Environmental Planning Commission

Agenda Number: 6
Project #: 2020-003658
SI-2020-00356

2nd Supplemental Staff Report

Agent	Consensus Planning, Inc.
Applicant	Greystar
Request	1) Major Amendment to Site Plan –EPC
Legal Description	Tracts 1-6 North Andalucia at La Luz Tract 4 North Andalucia at La Luz
Location	SE corner of Coors Blvd. NW and Montano Rd.
Size	Approximately 60 acres
Zoning	R-MH

Figure 1: Continuous View Plan

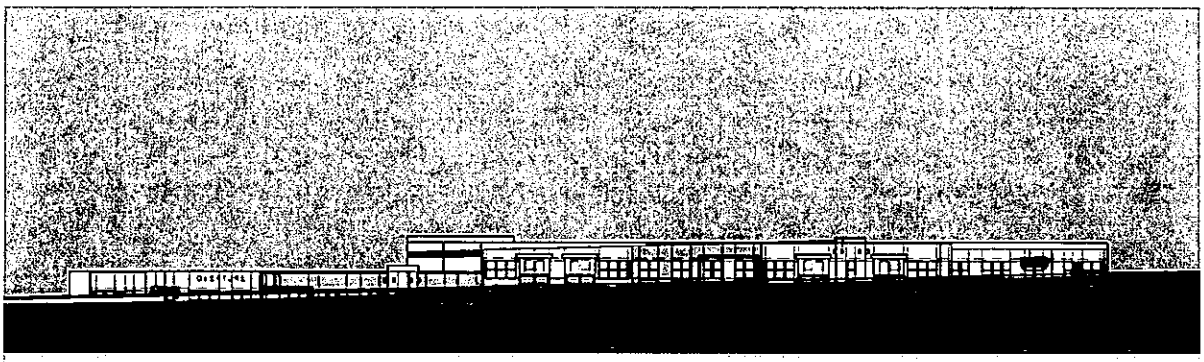
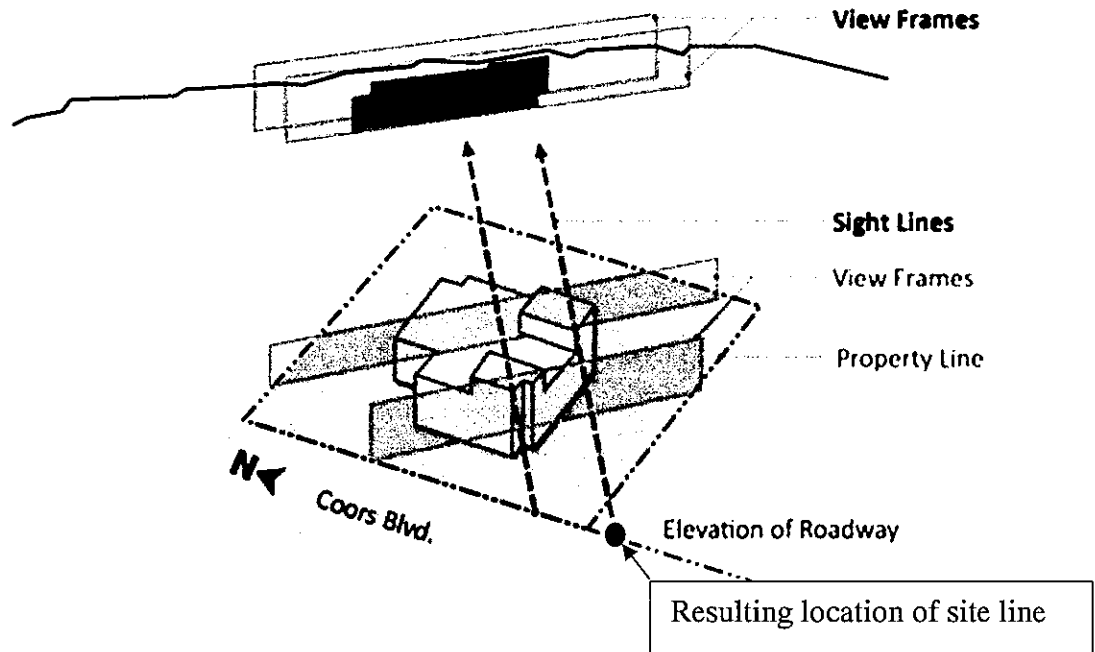
The applicant has submitted a revised design which removes the third story from the building along Coors Blvd. at the lower elevations. The lower building height places most of the building in compliance with the view plane analysis. A portion still remains more than 1/3 above the plane ranging from 2'4" down to 0 over a 75' distance.

On the eastern side of the building the degree of non-compliance is slightly higher ranging from 5'-3' down to 0 over 100'. This portion, being further from Coors would have less impact than the west part of the building.

Staff has interpreted this View Plane to be a sloping plane since the right driving lane of Coors is sloping. The ZEO has confirmed the appropriateness of this method in his determination.

The proposed building has been redesigned to remove the third-floor portion of the primary building from the northwest corner of the building. The unit count is maintained by adding a three-story section through the middle of the courtyard. The highest point of the building remains at 39'-0" along the eastern elevation. The placement of the original View Frame is determined by establishing a sightline that runs from the Coors right-of-way at a 45-degree angle towards the Sandia Mountains and passing through the highest point of the building. That resulting location was approximately 70 feet to the south of the site.

3. Building should be reduced by either the extent to which the height is over the View Plane by more than 1/3 of the building height or by removal of the third floor in those area.

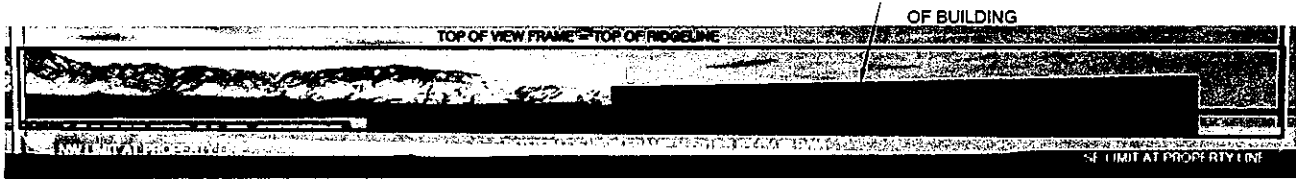
The View Frame should result in a slice of the building at the frame location. The View Frame provided by the applicant show the building with a tapering roof line as in perspective. This should not be the case. The building height should be at a straight height.

When correcting the applicant's perspective on the view frames, the amount of blockage from the buildings is less than presented.

All view frames of the revised design fall within the View Frame parameters of less than 50% blockage of the frame.

VIEW ANALYSIS	
VIEW FRAMES (STILLS FROM VIDEO)	
Date	08/20/20
Drawn By	PSA
Checked By	
Scale	1" = 200'
Sheet No.	2300
Sheet	1
Of	84
Of	CF

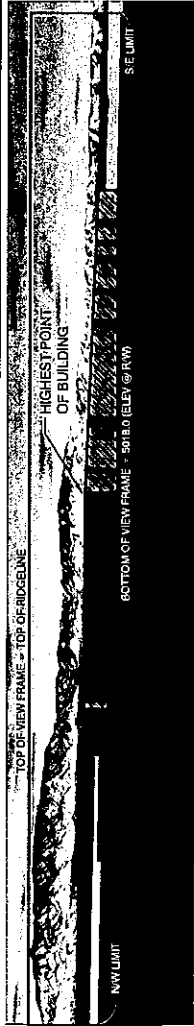
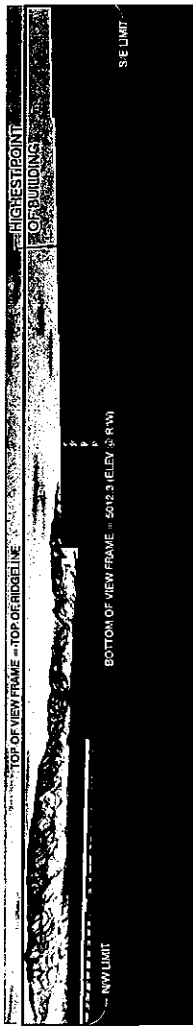
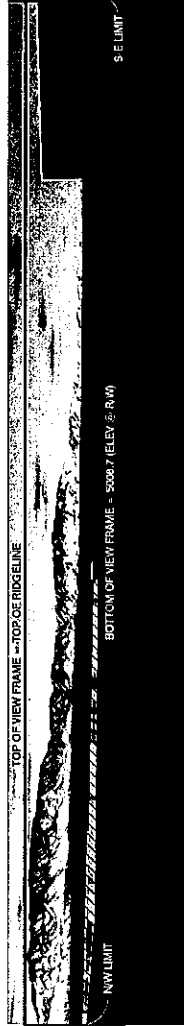
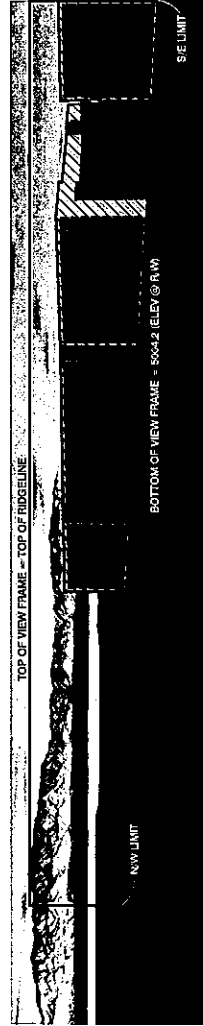
31.4%

View Frame A1

35.8%

View Frame A2

45%

View Frame B
